Technical Service Bulletin

SUBJECT:		No: TSB-18-52B-003	
UPDATES TO SRS AIRBAG DIAGNOSTIC TROUBLE CODE PROCEDURES - SERVICE MANUAL REVISION		DATE: December 2018	
		MODEL: 2013-14 i-MiEV	
CIRCULATE TO:	☐ GENERAL MANAGER	☒ PARTS MANAGER	☒ TECHNICIAN
☒ SERVICE ADVISOR	☒ SERVICE MANAGER	☐ WARRANTY PROCESSOR	☐ SALES MANAGER

This TSB updates the Supplemental Restraint System (SRS) section of the affected Service Manuals to provide corrected diagnostic information for front and side impact sensors.

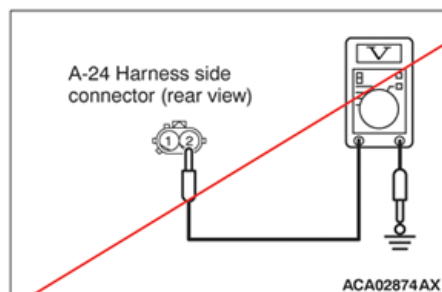
Please make the indicated changes to the 2013 (Canada only) and 2014 i-MiEV Service Manual, Group 52B - Supplemental Restraint System (SRS) -> SRS Air Bag Diagnosis -> Diagnostic Trouble Code Procedures <SRS-ECU>: Replace the Incorrect information with the Correct information for DTC B1407, Diagnosis.

STEP 3. Check the harness wires for open circuit or short circuit between SRS-ECU connector B-113 (terminal No.18 and 28) and front impact sensor (RH) connector A-24 (terminal No.2 and 1).

NO : Repair the harness wires between SRS-ECU connector B-113 and front impact sensor (RH) connector A-24. Then go to Step 4.

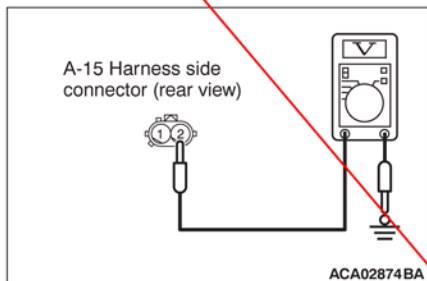
Please make the indicated changes to the 2013 (Canada only) and 2014 i-MiEV Service Manual, Group 52B - Supplemental Restraint System (SRS) -> SRS Air Bag Diagnosis -> Diagnostic Trouble Code Procedures <SRS-ECU>: Replace the Incorrect information with the Correct information for DTC B1417, Diagnosis.

STEP 3. Check the front impact sensor (LH) power supply circuit. Measure the voltage at the front impact sensor (LH) connector A-15.

STEP 3. Check the harness wires for open circuit and short circuit between SRS-ECU connector B-113 (terminal No.17 and 27) and front impact sensor (LH) connector A-15 (terminal No.2 and 1).

NO : Repair the harness wires between SRS-ECU connector B-113 and front impact sensor (LH) connector A-15. Then go to Step 4.

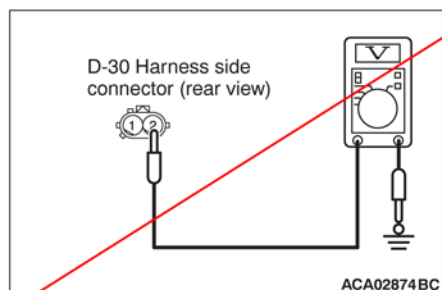
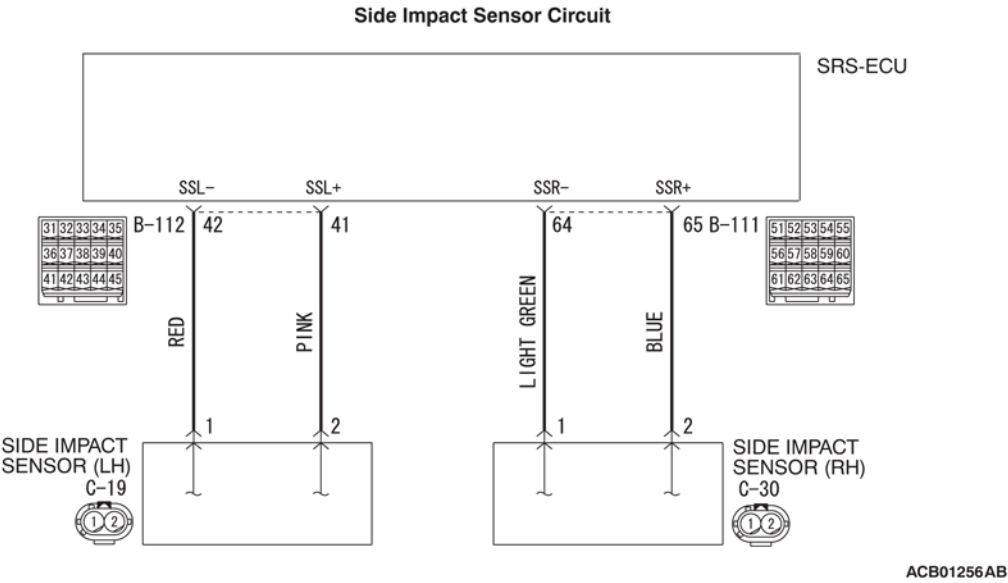
Please make the indicated changes to the 2013 (Canada only) and 2014 i-MiEV Service Manual, Group 52B - Supplemental Restraint System (SRS) -> SRS Air Bag Diagnosis -> Diagnostic Trouble Code Procedures <SRS-ECU>: Replace the Incorrect information with the Correct information for DTC B1427, Diagnosis.

STEP 3. Check the harness wires for open circuit or short circuit between SRS-ECU connector B-111 (terminal No.64 and 65) and side impact sensor (RH) connector C-30 (terminal No.1 and 2).

STEP 4. Check the harness wires for open circuit or short circuit between SRS-ECU connector B-111 (terminal No.65) and side impact sensor (RH) connector C-30 (terminal No.2).
Q: Are the harness wires between SRS-ECU connector B-111 (terminal No.65) and side impact sensor (RH) connector C-30 (terminal No.1) in good condition?
YES : Erase the diagnostic trouble code memory, and check the diagnostic trouble code. If DTC B1427 sets, replace the SRS-ECU (Refer to P.52B-275). Then go to Step 5.
NO : Repair the harness wires between SRS-ECU connector B-111 and side impact sensor (RH) connector C-30. Then go to Step 5.

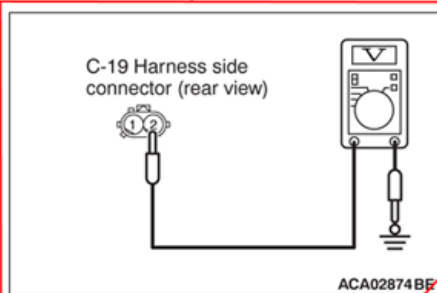
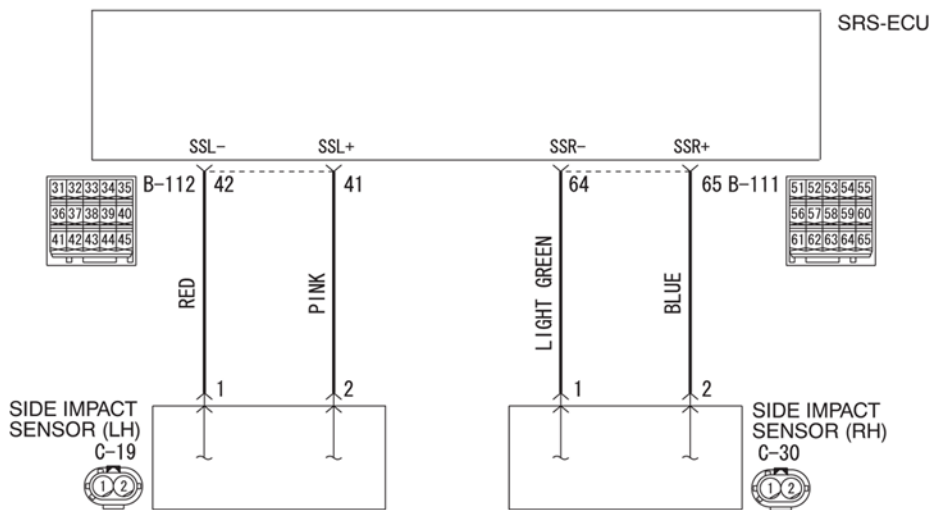
Please make the indicated changes to the 2013 (Canada only) and 2014 i-MiEV Service Manual, Group 52B - Supplemental Restraint System (SRS) -> SRS Air Bag Diagnosis -> Diagnostic Trouble Code Procedures <SRS-ECU>: Replace the Incorrect information with the Correct information for DTC B1437, Diagnosis.

STEP 5. Replace the side impact sensor (LH).

- (1) Replace the side impact sensor (LH) (Refer to GROUP 52B, Side Impact Sensor).
- (2) Turn the electric motor switch to the "ON" position.
- (3) Check if the DTC is set.
- (4) Turn the electric motor switch to the "LOCK" (OFF) position.
